West Gate Tunnel Project IAC

West Gate Tunnel Project

Environmental Effects Statement
Hobsons Bay City Council Submission

July 2017

Figure 1. Suggested new Freeway entry/exit ramps (red and blue arrows)

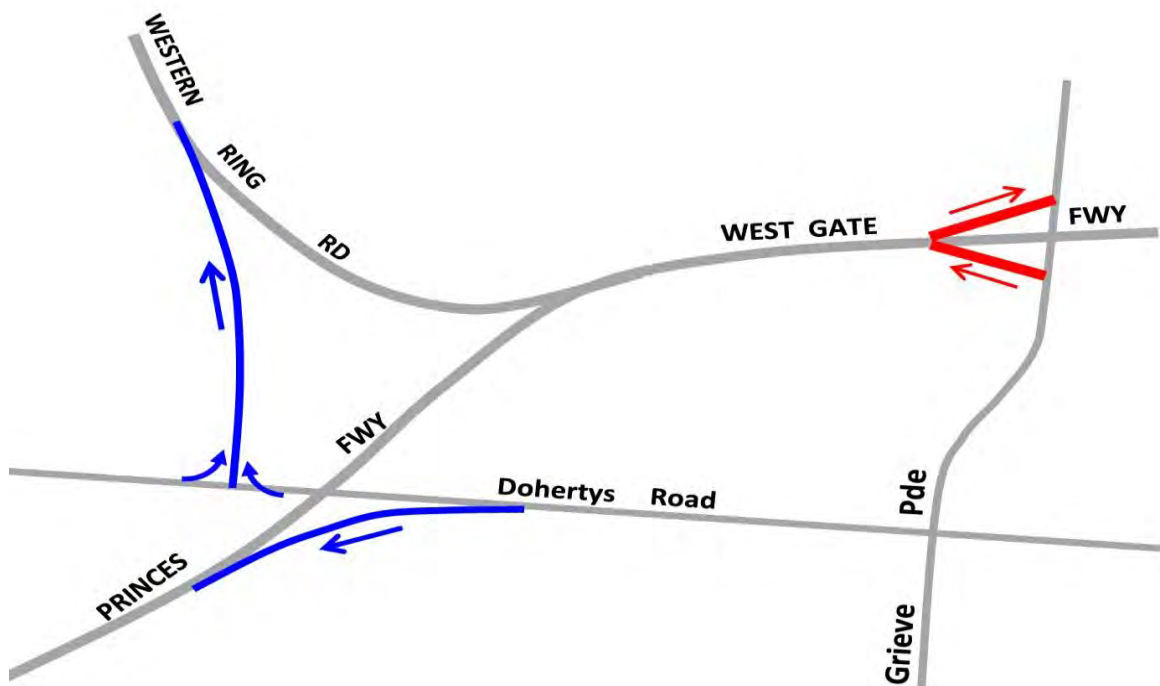
Council has been working with VicRoads to encourage truck traffic to use Grieve Parade (an industrial precinct) rather than Millers Road. Millers Road in Brooklyn and Altona North traverses residential areas, activity centres and school zones. Brooklyn residents currently experience access difficulties, delays and safety issues due to the increasing volumes of trucks using Millers Road.

Due to the lack of Freeway access ramps at Grieve Parade, north south connectivity to the M80 is restricted. Council's adopted position calls for new access ramps at Dohertys Road to be included with the proposed duplication works to improve local industry connectivity and freight movement efficiency (refer Figure 1 below). This has not been adopted by VicRoads in the proposed Dohertys road duplication works or in the recent design of the M80 interchange with the West Gate Tunnel. HBCC requests that this issue be addressed in the WGT Project.

Figure 2. Missing Noise Wall at Precinct 15

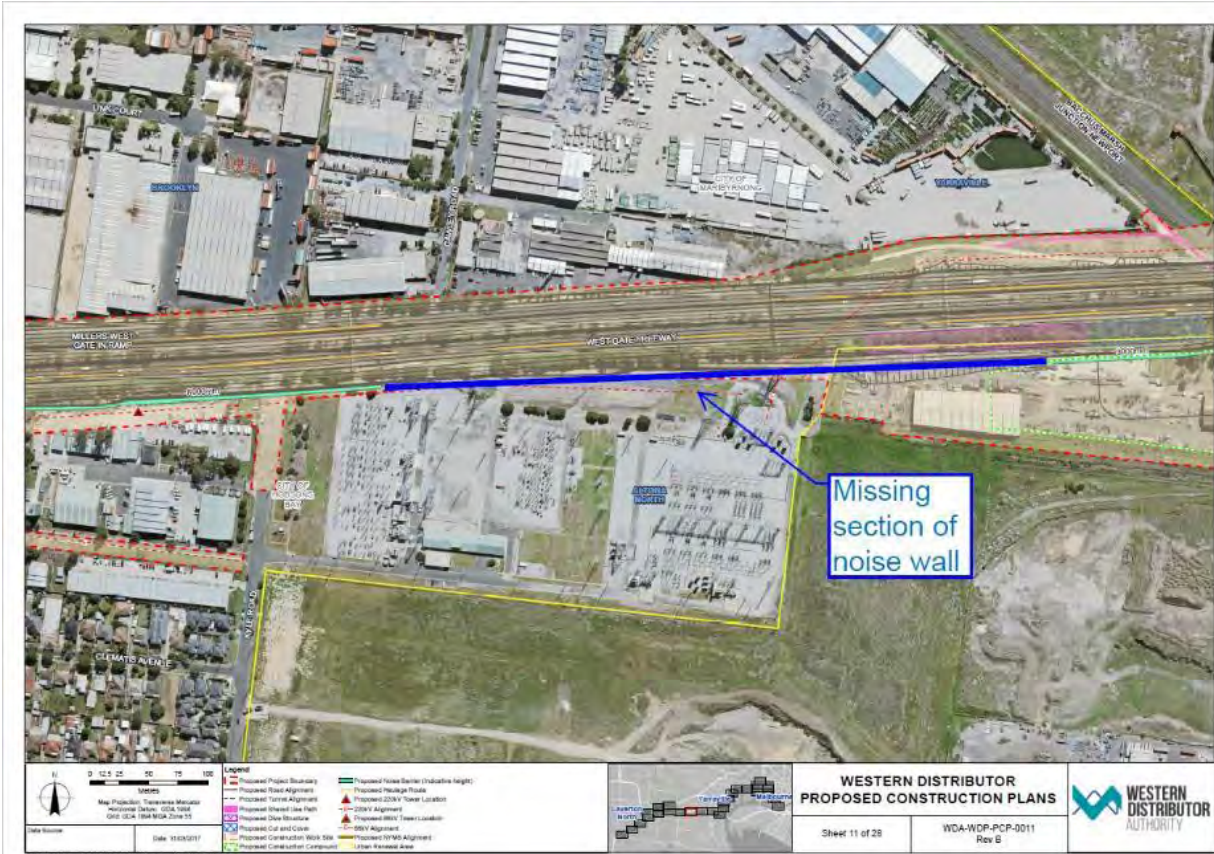
Currently, the Terminal Station is significantly masked by established vegetation along the road verge (with the layered effect of shrub and canopy planting – Cyprus sp.). The widening of the road ways and removal of such vegetation will allow for direct views of Freeway users towards this unsightly facility (particularly impacting on views when exiting the southern tunnel portal). This would provide a negative first impression and arrival experience of the western suburbs. While land use is a key influence on the location of new sound walls, Council believes

that is further opportunities to conceal views towards the Brooklyn Terminal Station with extending the sound walls some additional 500m. Refer to Figure 2.

Additionally, given that there is anticipated residential development is to occur south of the terminal (i.e. Precinct 15), there is merit in extending the sound walls from New Street to Kyle Road.

Drawing Ref: HBCC TRAF 01
 Refer Council Adopted
 Recommendations #4 - 6 - 7

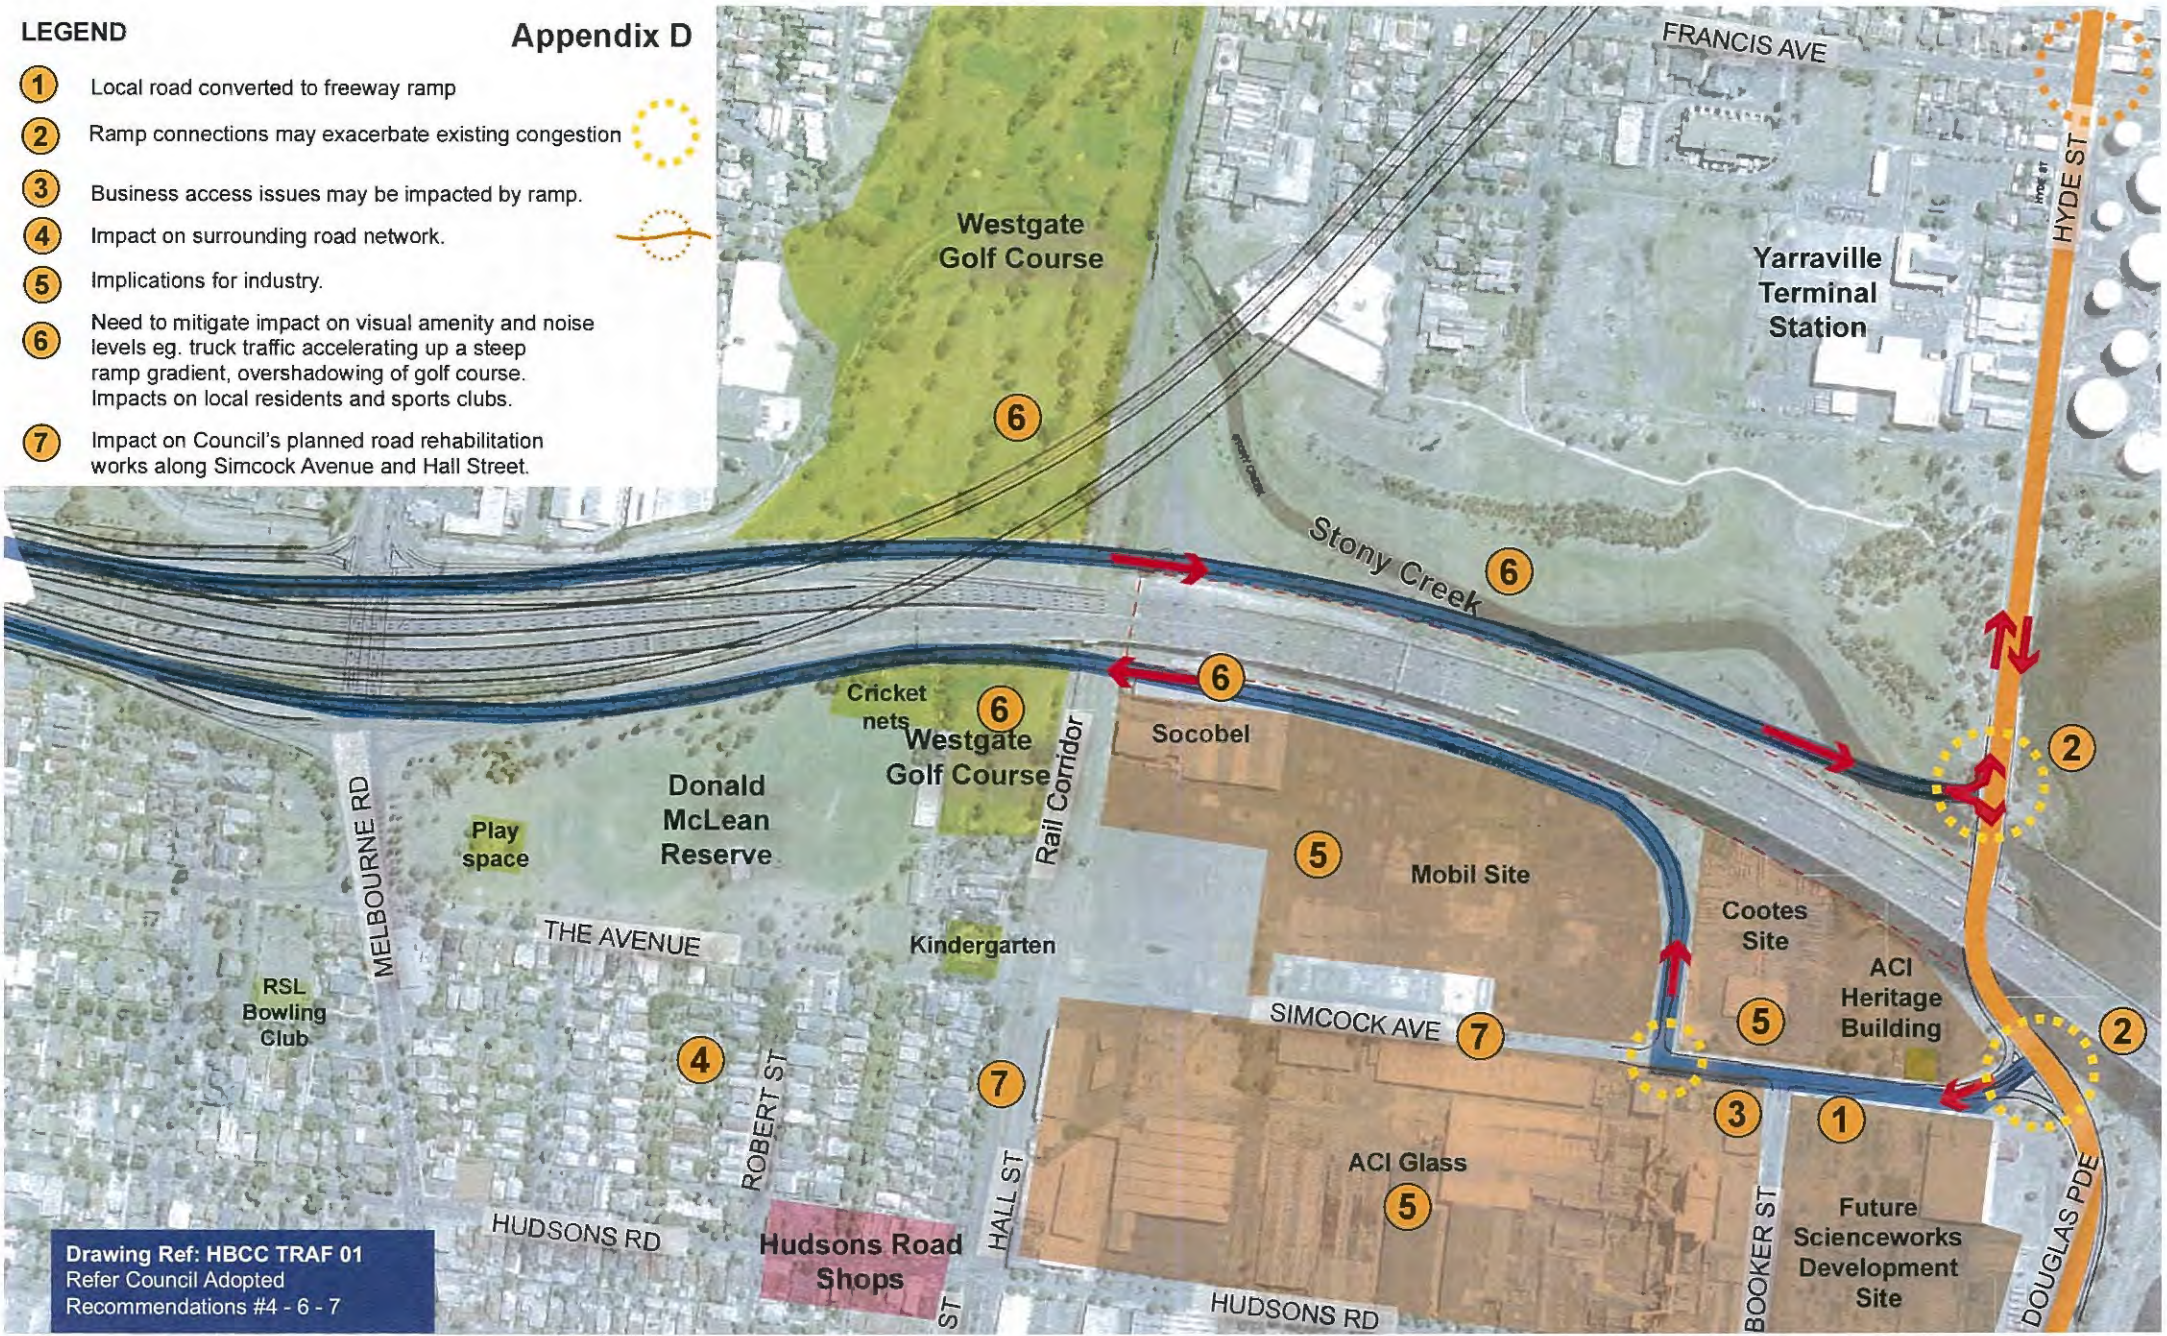
- ① Local road converted to freeway ramp
- ② Ramp connections may exacerbate existing congestion
- ③ Business access issues may be impacted by ramp.
- ④ Impact on surrounding road network.
- ⑤ Implications for industry.
- ⑥ Need to mitigate impact on visual amenity and noise levels eg. truck traffic accelerating up a steep ramp gradient, overshadowing of golf course. Impacts on local residents and sports clubs.
- ⑦ Impact on Council's planned road rehabilitation works along Simcock Avenue and Hall Street.

Drawing Ref: HBCC ACW 01
 Refer Council Adopted
 Recommendations #21 - 22 - 23

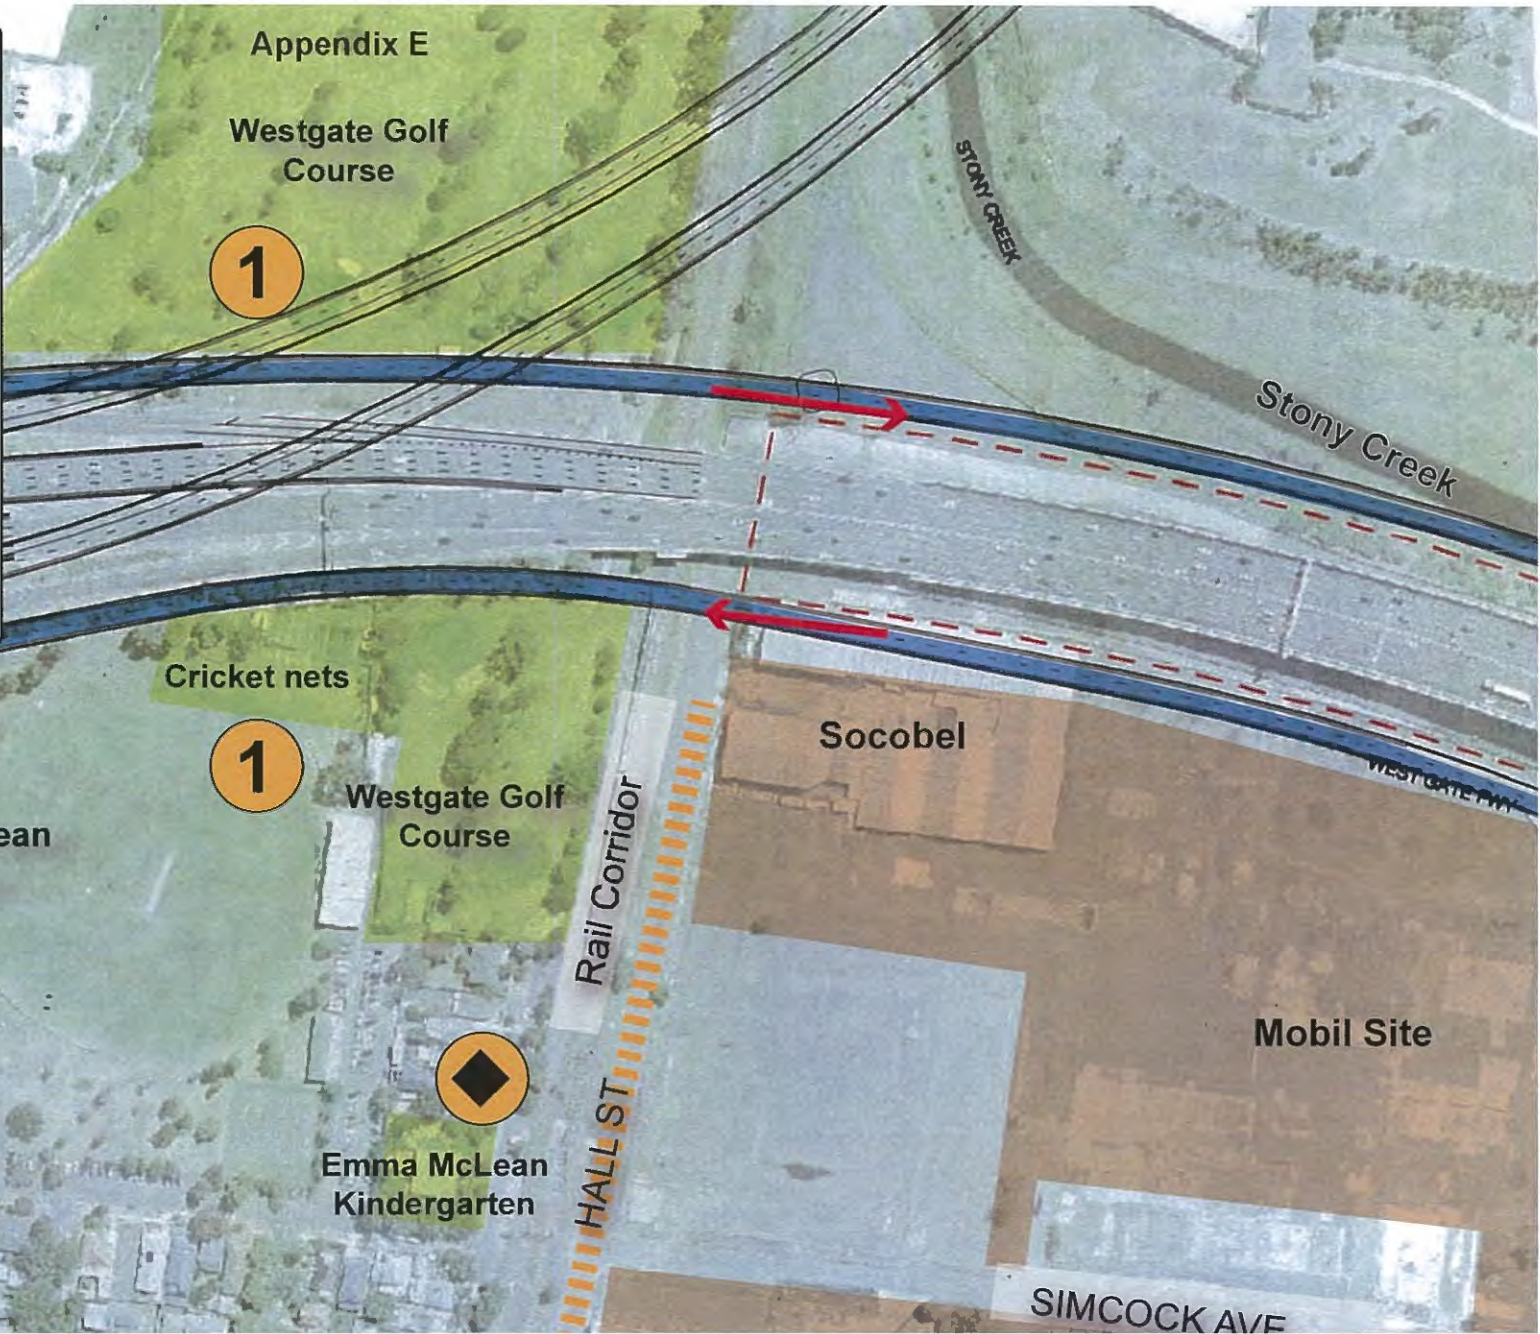
◆ Ramps will be 20m closer towards existing kindergarten with associated impacts of noise and air pollution.

||||| Depending on eastern Simcock Ave connection, more traffic will need to travel west.

Drawing Ref: HBCC TRAF 02
Refer Council Adopted Recommendations #9 - 12

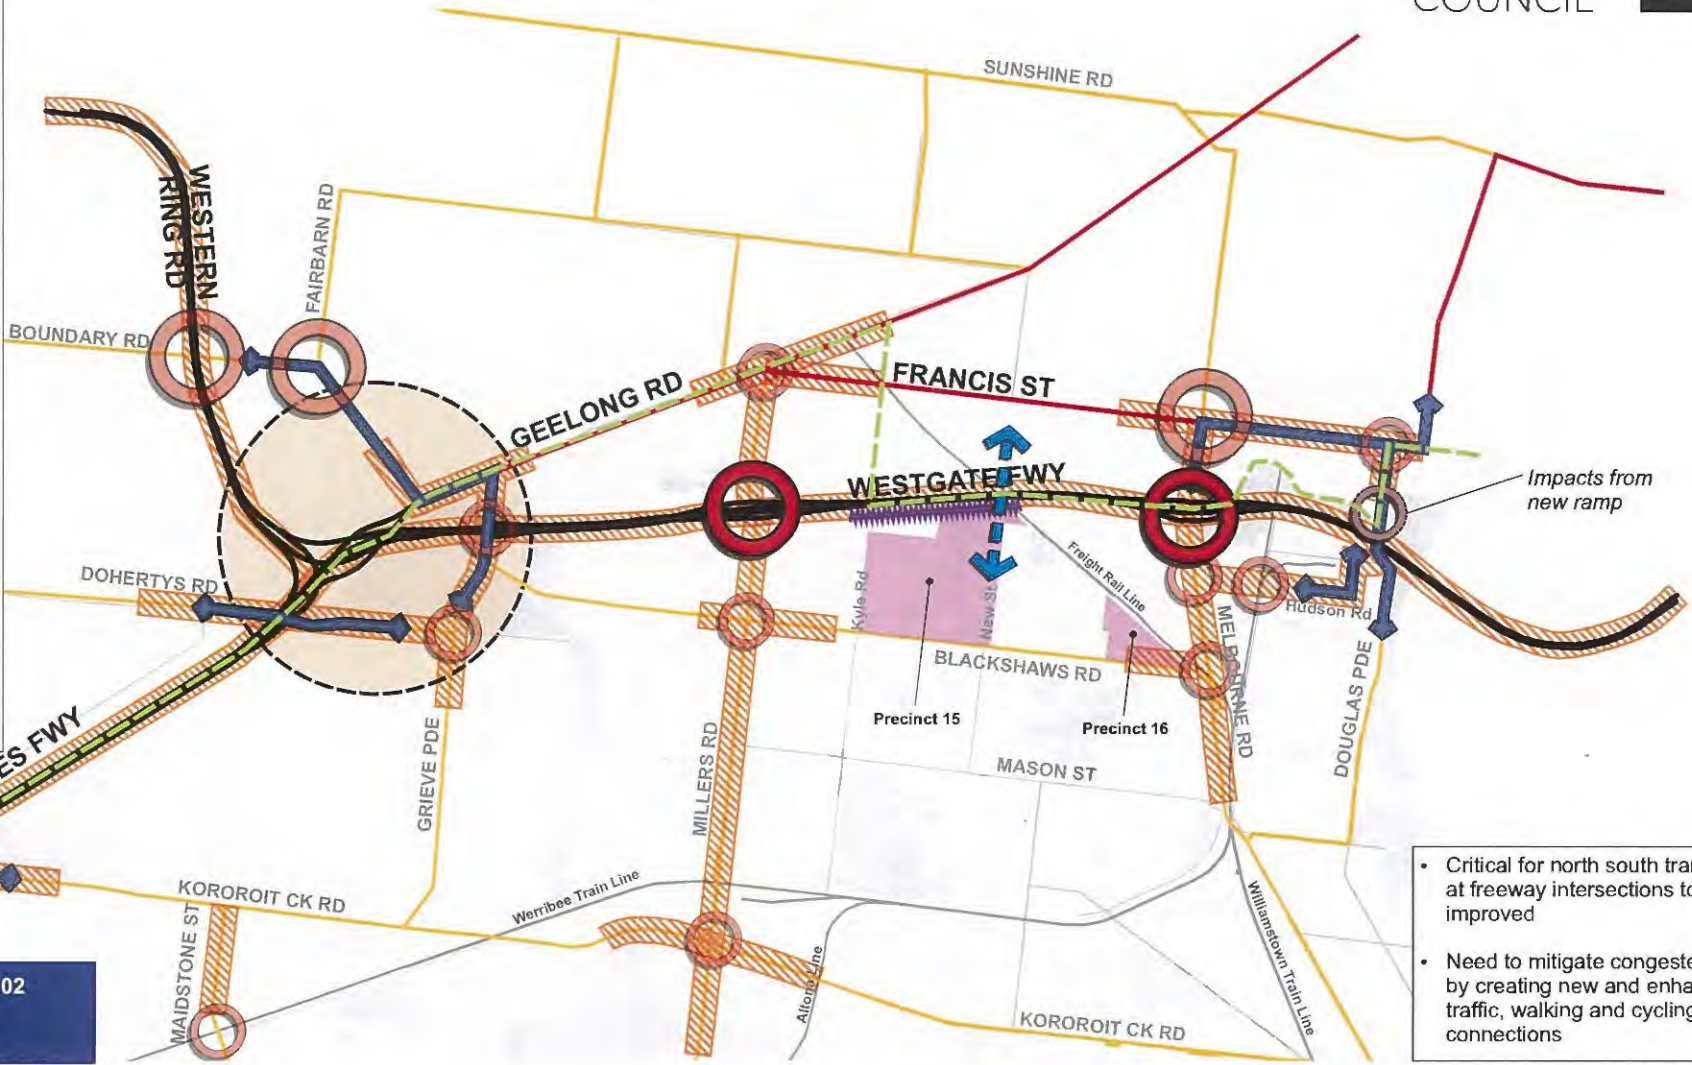
- ①**
- 1A Requires underpass of West Gate Freeway connecting Kyle Road with Cawley Road
 - 1B Creates undesirable industrial/ commercial/ residential traffic interface
Currently there is no controlled intersection treatment with Francis St/ Cawley Rd
 - 1C Unmade section of Kyle Road would need to be constructed

- ②**
- 2A Requires underpass of rail line to connect New Street with The Avenue
 - 2B Gas line location to be identified
 - 2C Provides a link to Fogarty Avenue and "McIvor Road" (unconstructed road adjacent to the Bradmill redevelopment) that will be signalised at Francis Street creating safe access to an arterial road

- ③**
- 3A Road alignment along the west edge of railway line connecting to Cawley Road and Francis Street.
 - 3B Creates undesirable industrial/ commercial/ residential traffic interface
Currently there is no controlled intersection treatment with Francis St/ Cawley Rd
